ADDENDUM NO. 3

**RE: Item #1, July 29, 2026 Letting - EM-P 0044(207)290, PCN 05X0, Charles Mix, Gregory
County - Structure (5770'-6" Steel Girder) & Approach Grading**

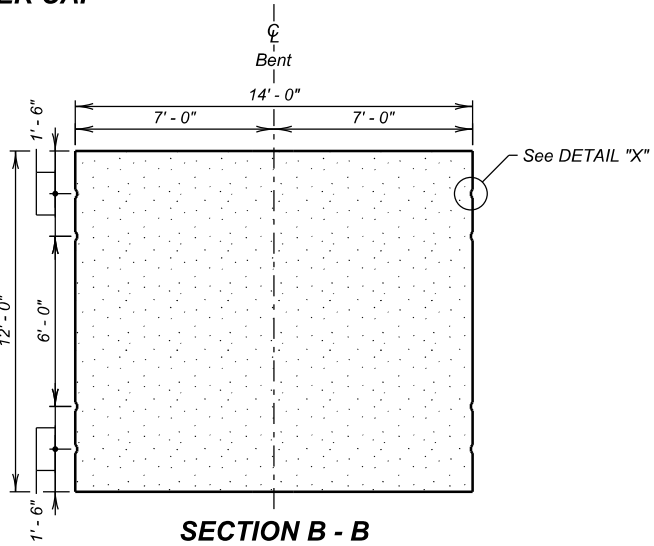
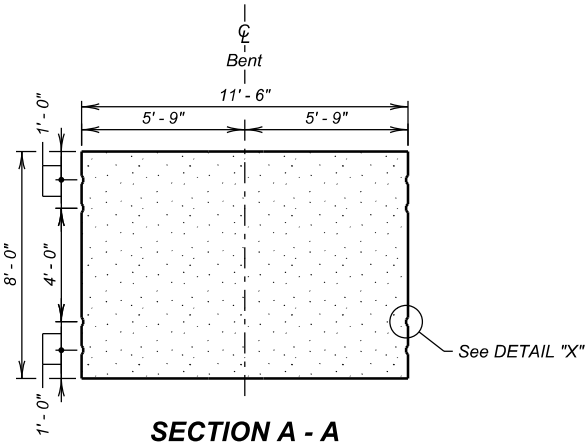
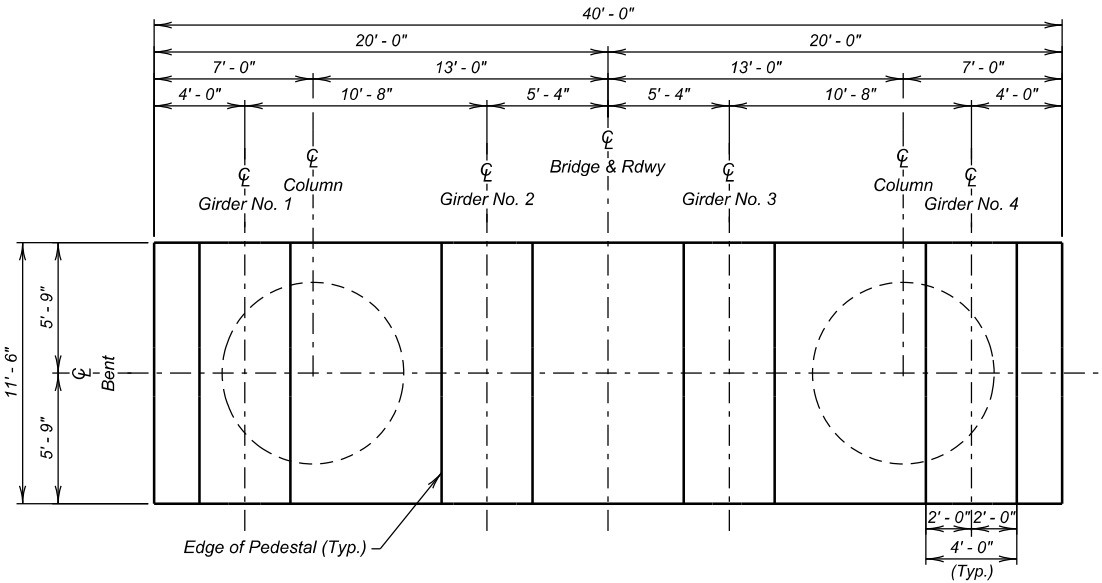
Sheets E28 & E31: Elev. "C" was revised on ELEVATION view.
